Amendment
Customer No.: 24498
Serial No. 10/797,682
Page 5

Remarks/Arguments

Appln. No. 10/797,682
Amendment Dated Reply to Office Action of 06/16/2005
ANNOTATED SHEET SHOWING CHANGES

FIG. 3

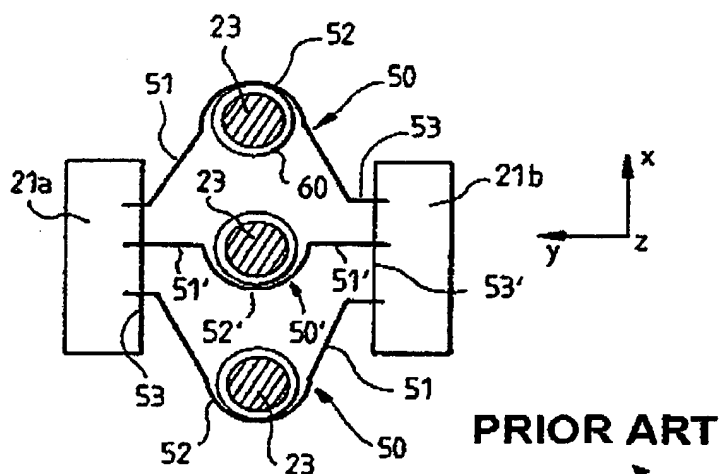
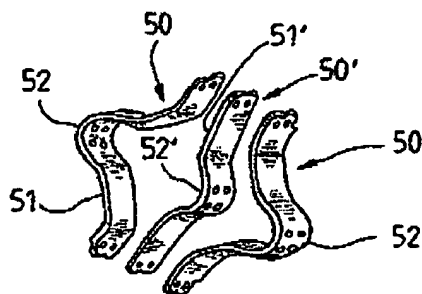
In response to the objection to Figures 3 and 4, Applicants amend Figures 3 and 4 to include the expression "Prior Art." Applicants respectfully request reconsideration of the objection.

Expression: PRIOR ART
Added
